Product Change Notification / ALAN-09TNMZ646

CCB 4981 Final Notice: Qualification of A194 as an additional Lead-frame for various device families available in 44L PLCC (16.6x16.6x4.4mm) package.

CCB 4981
Pre and Post Change Summary
PCN# ALAN-09TNMZ646

Pre and Post Change Summary

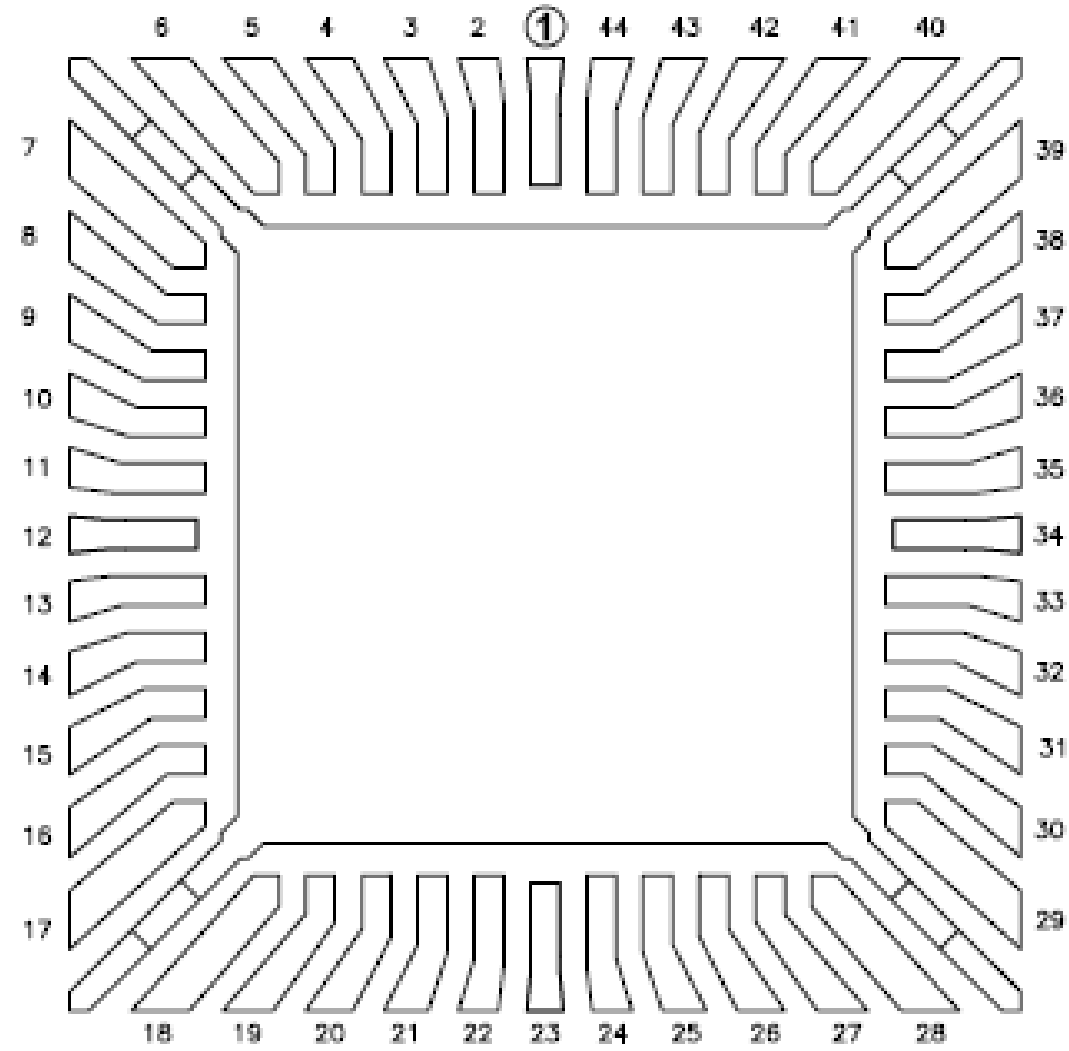
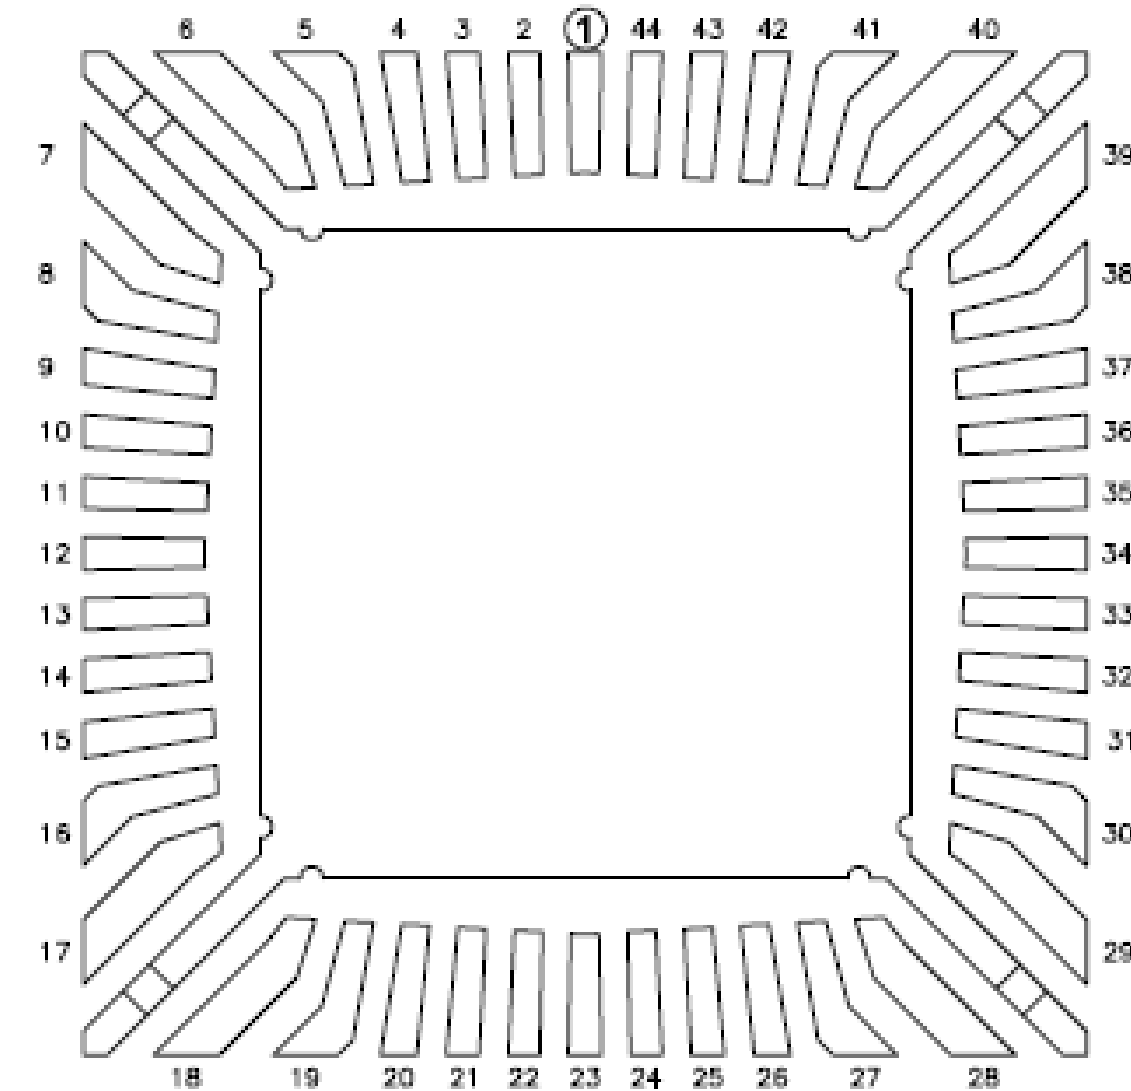
Description of Change: Qualification of A194 as an additional Lead-frame for various device families available in 44L PLCC (16.6x16.6x4.4mm) package.

Material	C151
DAP Surface Prep	Ag Spot plated
Treatment	None
Process	Stamped
Lead-Lock	No

Material	A194
DAP Surface Prep	Bare Cu
Treatment	BOT
Process	Etched
Lead-Lock	No
